**Disposition of Surplus
Highly Enriched Uranium
Final Environmental
Impact Statement**

Comment Analysis and Response Document

June 1996

Disposition of Surplus Highly Enriched Uranium Final Environmental Impact Statement
(DOE/EIS-0240)

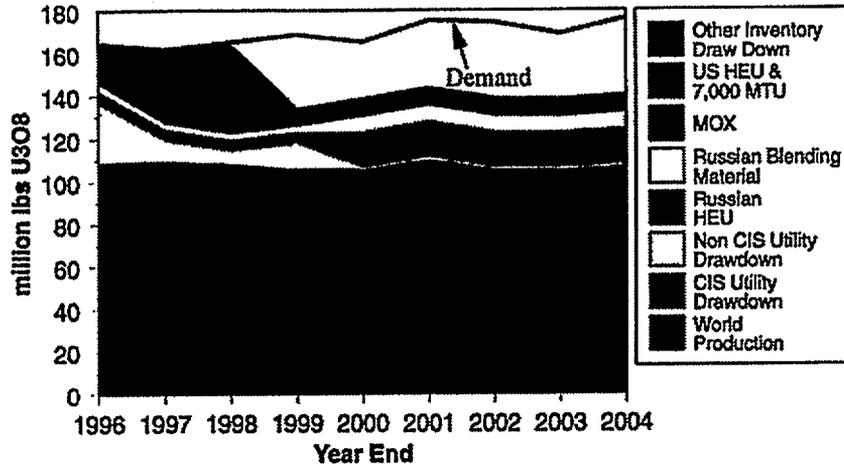
This shows the drawdown of 5 MTU @ 70%, 45 MTU @ 37.5%, and 120 MTU @ 45% of US HEU blending to 4.0% (not including the blending material) and 7,000 MTU of natural uranium

This material represents the following UO8:

5 MTU @ 70% and 45 MTU @ 37.5%	lbs UO8
120 MTU @ 45%	12,800,000
7,000 MTU Natural	31,900,000
TOTAL	18,200,000
	64,900,000

The drawdown of this uranium is limited to 4,000,000 lbs/year starting in 1998 pursuant to the USEC Privatization Bill (S.755). HEU blending capacity of 10 MTU of HEU per year is also a limiting factor. At 10 MTU of HEU per year it would take 17 years to blend the HEU mentioned above. If the 64,900,000 lbs UO8 is delivered over 17 years this would represent 3,800,000 UO8/year
